NEMA Comments on Draft ENERGY STAR® Program Lamp Specification v1.0 Draft 3

NEMA Comments to ENERGY STAR Specification for Lamps Version 1.0 Draft 3

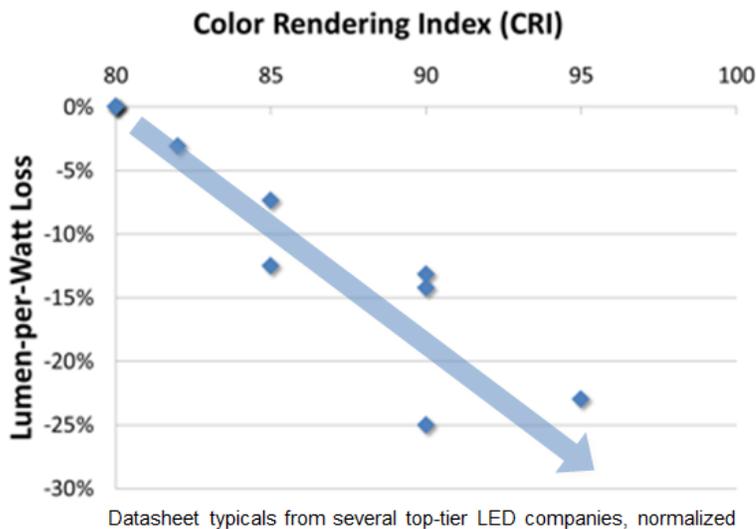
We reiterate our previous comment that high-CRI lamps need a break on efficacy requirements, due to the tradeoff between CRI and LPW. As is shown below, in this case for SSL, current technology limits result in a direct proportionality between CRI and efficacy loss.

The objective of this comment is that >90 CRI lamps become available to the market as a reasonable alternative to 80CRI. In the absence of a lower efficacy tier, >90 CRI lamps have a fundamental cost disadvantage in the market.

In the case of Phosphor based white LEDs, increased CRI from 80 to 90 is achieved by increased spectral emission across a broader wavelength range. This results in a reduction of luminous efficacy of approximately 20% on average for leading LED manufacturers. A lamp specification that allows a 1 for 1 lower lamp efficacy will limit the cost increase for higher CRI lamps and allows manufacturers to offer them at competing prices. This will level the playing field between lamps of different CRI and allows consumers and commercial users to make a balanced choice when they try to find alternatives to replace halogen and incandescent lamps. Otherwise, consumers who demand high-CRI lighting will stick with inefficient sources. Even with a slightly reduced efficacy requirement for >90 CRI, the expected energy savings for replacing an incandescent or halogen lamp is still 75%. The overall impact on energy savings is expected to be positive because the >90 CRI can be adopted in addition to products with lower CRI.

We think all parties concerned want to see high CRI lamps widely available for those who want them (retail, etc.) and ask the EPA to add a table which addresses this need in next draft for public feedback:

All lamps	Lamp Rated Wattage (Watts)	CRI > 90
Omnidirectional	<15	45
	≥15	55
Directional	<20	35
	≥20	40
Decorative	<15	35
	15 ≤ W < 25	40
	≥25	50
